Staff Report

Case No:	14devplan1084
Request:	Revised Development Plan
Project Name:	Arborage Village
Location:	201 Maple Valley Road
Owner:	CR Development, Inc.
Applicant:	CR Development Inc.
Representative:	Land Design and Development
Jurisdiction:	Louisville Metro
Council District:	19-Miller
Case Manager:	Julia Williams, AICP, Planner II

- Revised Detailed District Development plan

The proposal is to remove a sidewalk interior to the site that would connect the residences to Eastwood Cutoff Road.

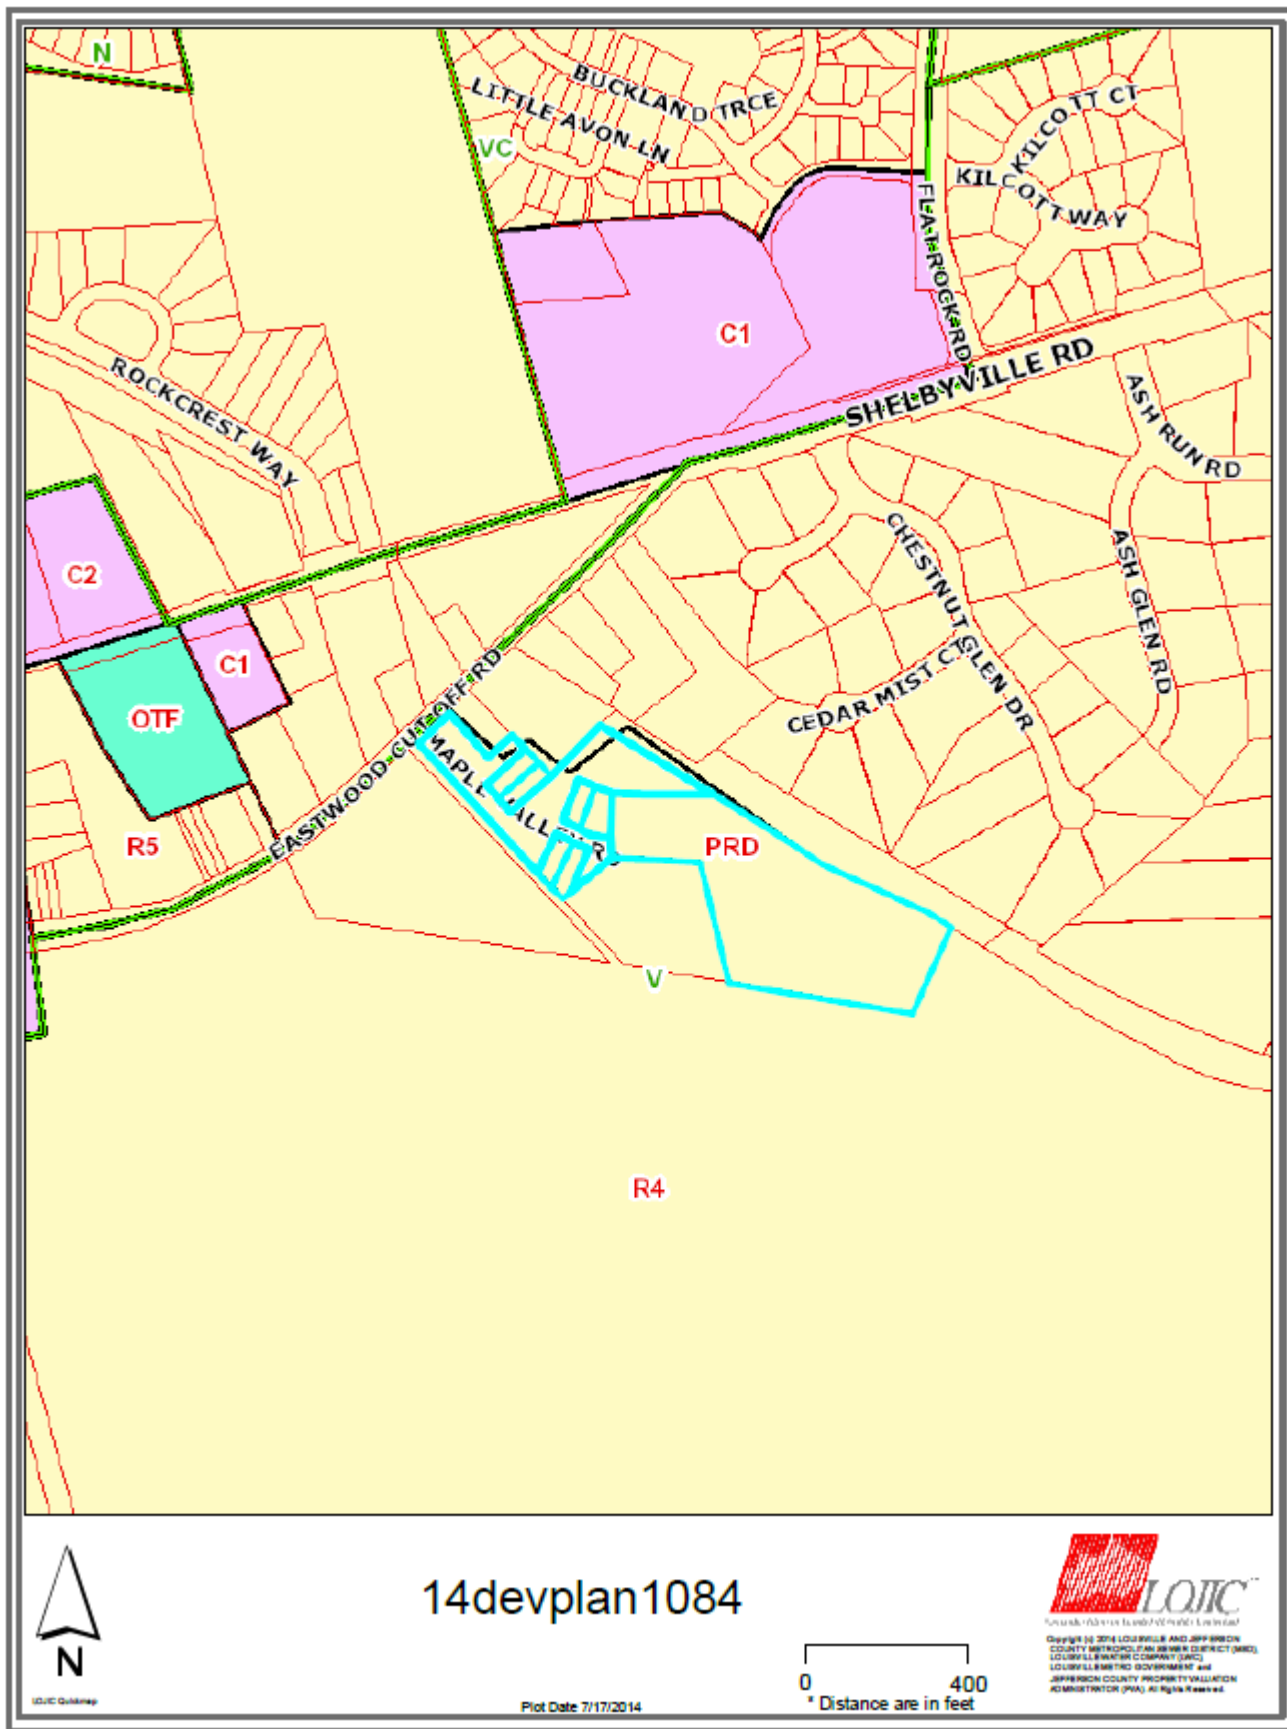
STAFF: The removal of the sidewalk prevents safe and efficient pedestrian transportation to and from Eastwood Cutoff Road. Eastwood Cutoff Road connects to Shelbyville Road where there are non-residential uses and zoning.

STAFF: The overall site design is not changing and has proven to be compatible via previous development plan approvals. However, the removal of the interior sidewalk reduces the compatibility of the site with future development as this site will no longer provide a safe connection for its residents to walk to other developments.

STAFF: While the sidewalk is not required by the Land Development Code it was provided on the development plan as a tool to comply with the Comprehensive Plan for the PRD zoning change. Not providing the sidewalk takes the site out of compliance with the circulation guidelines of Cornerstone 2020.

While the sidewalk is not required by the Land Development Code it was provided on the development plan as a tool to comply with the Comprehensive Plan for the PRD zoning change. Not providing the sidewalk takes the site out of compliance with the circulation guidelines of Cornerstone 2020 and the Eastwood Neighborhood Plan.
